## ADDENDUM NO. 2

DATE: February 10, 2025

PROJECT: ORCHARD VALLEY GOLF COURSE BRIDGE REPLACEMENTS

FROM: Engineering Enterprises, Inc.  
52 Wheeler Road  
Sugar Grove, Illinois 60554

DATE:	
PROJECT NO:	FVFDLEORCHARD S10 CONC' ABUTMENT PLAN
SHEET	<b>S10</b> OF <b>13</b>

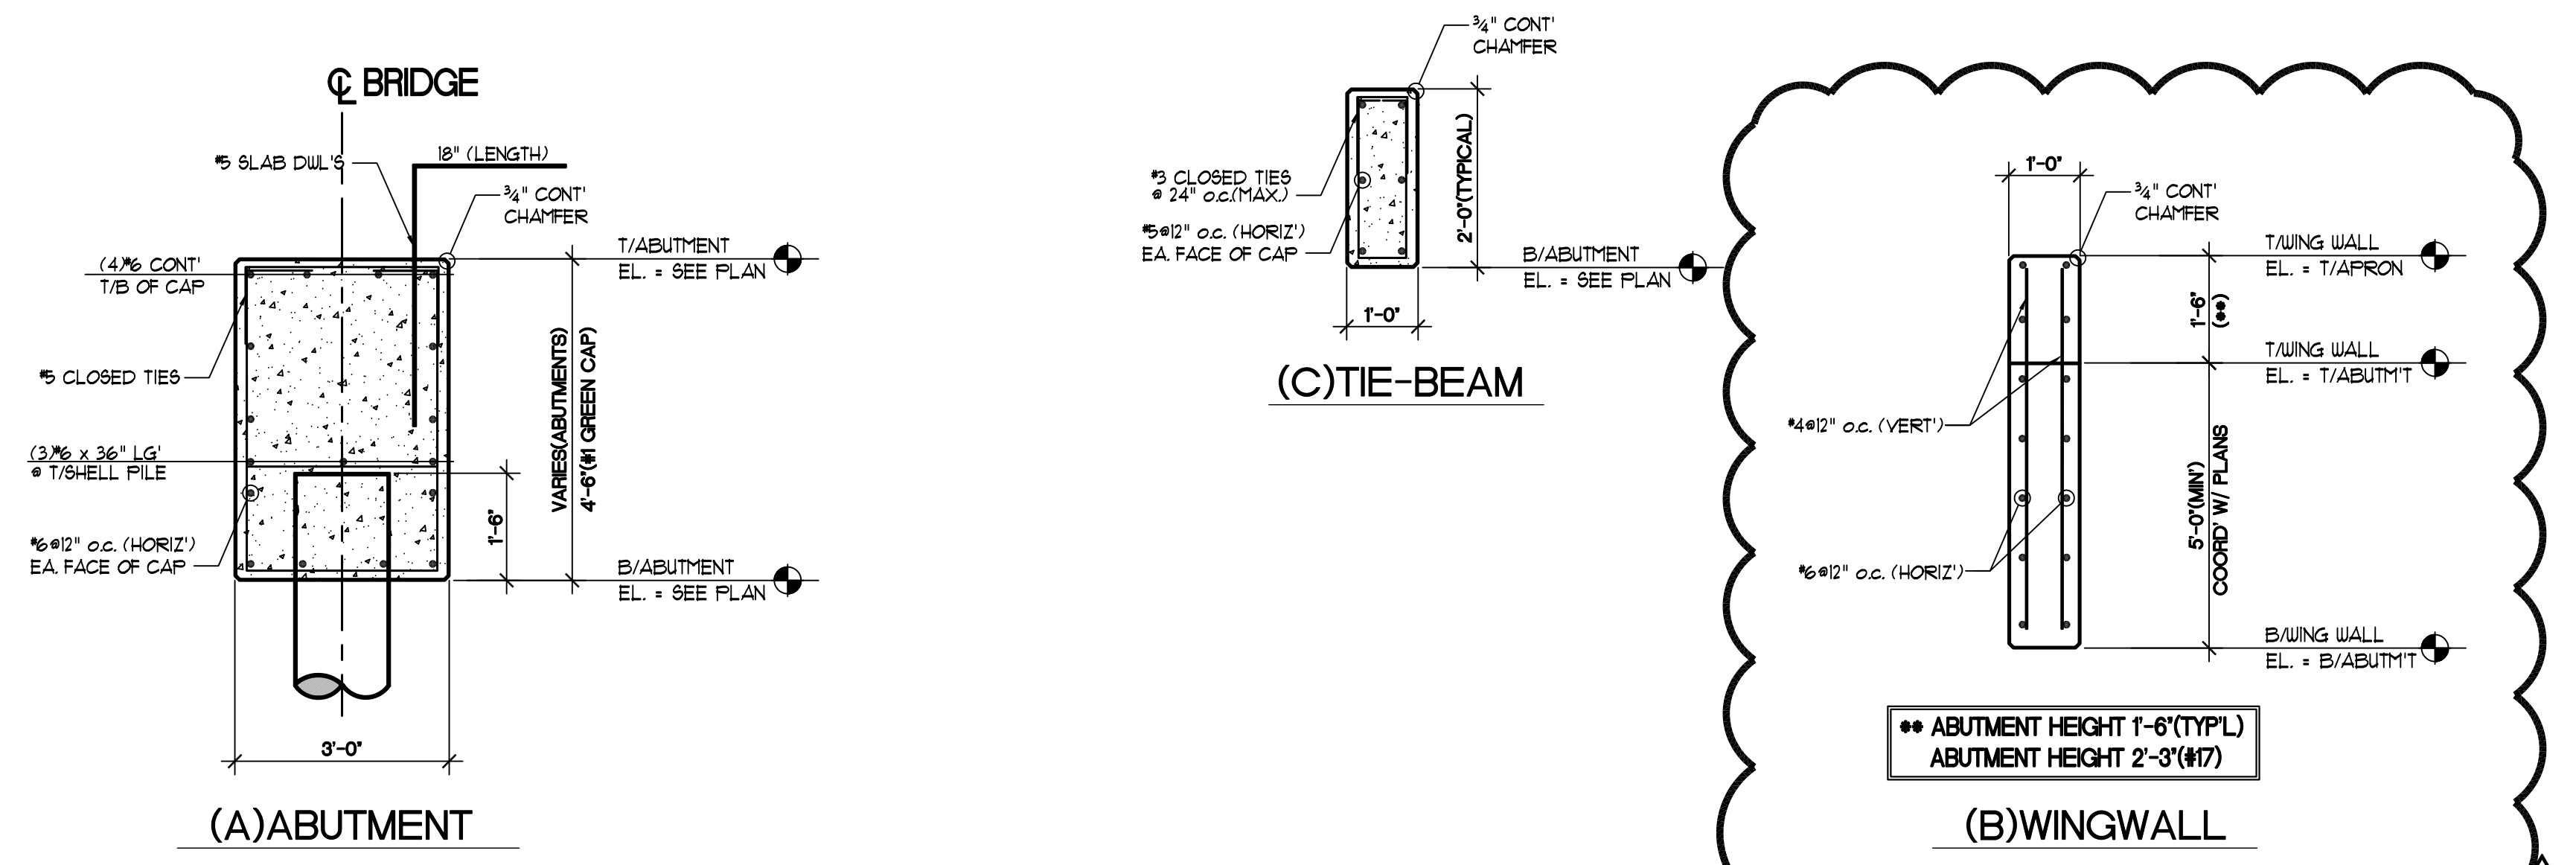
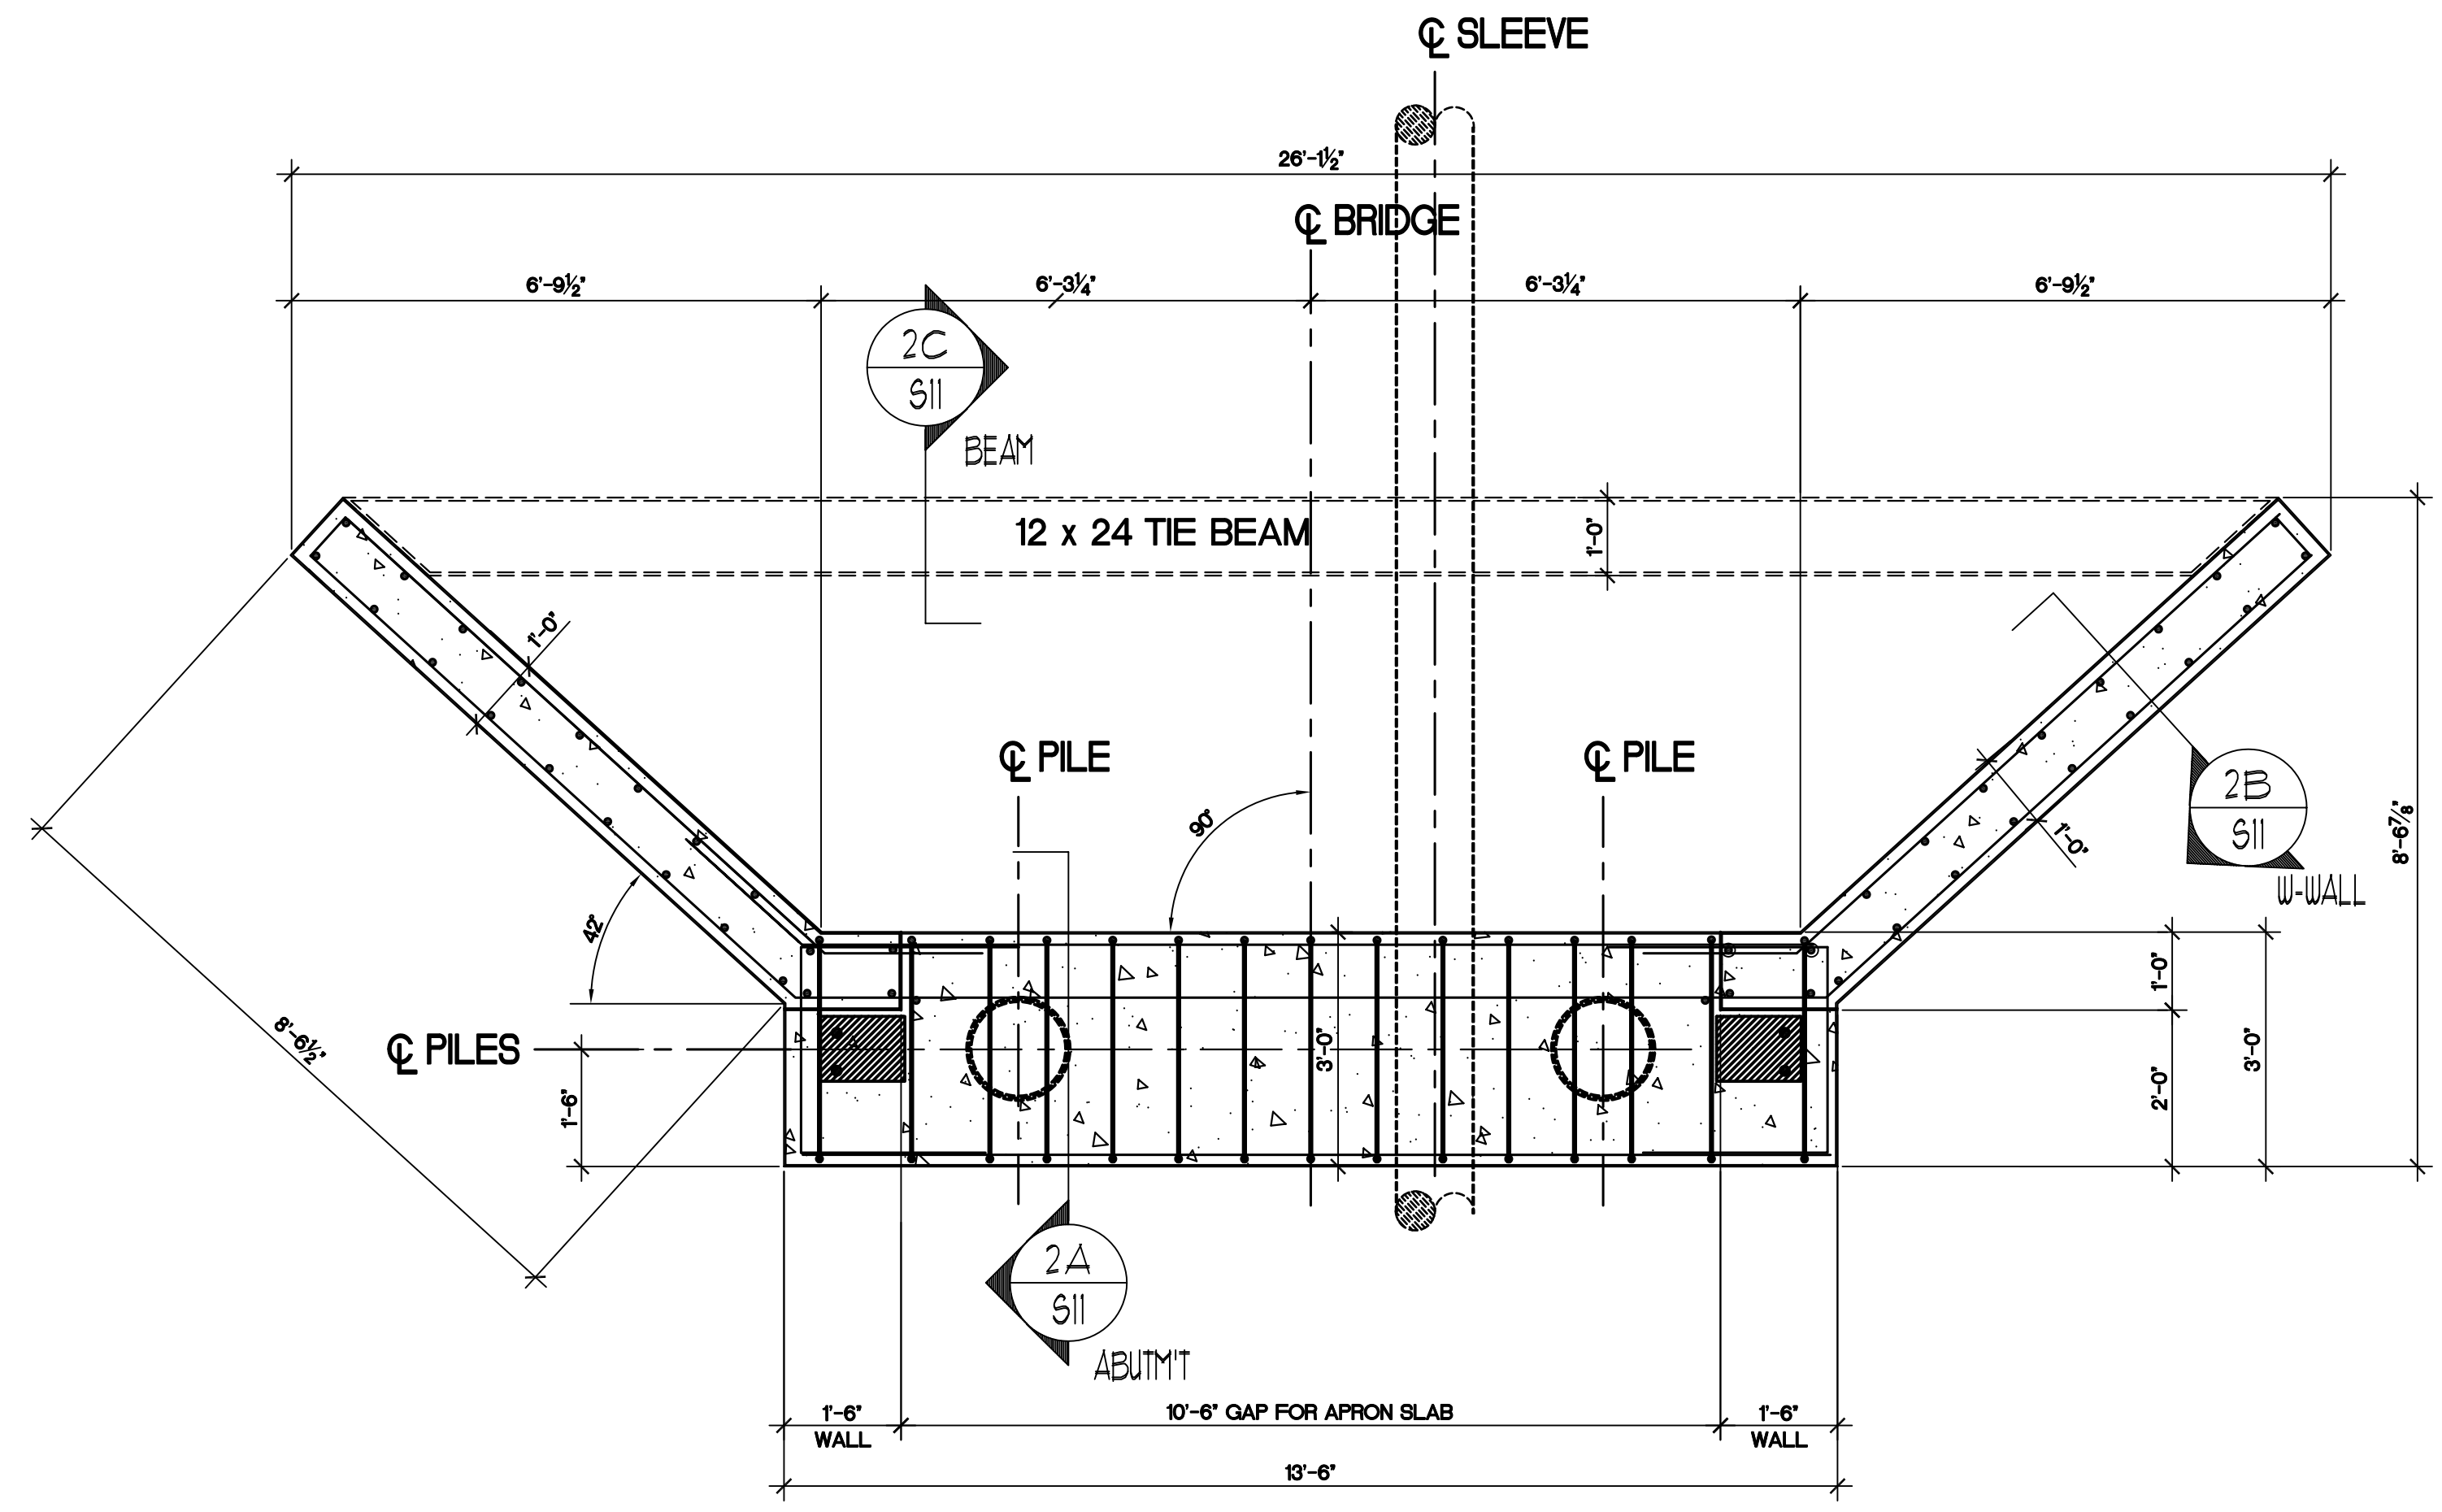
26. Civil plan sheets C16, C17, C18, C19, C20, and C21 have been revised for additional water line information and based on contractor questions. Structural plan sheets S2, S10, S11, and S12 have been revised based on contractor questions. All revised sheets are included with this addendum.
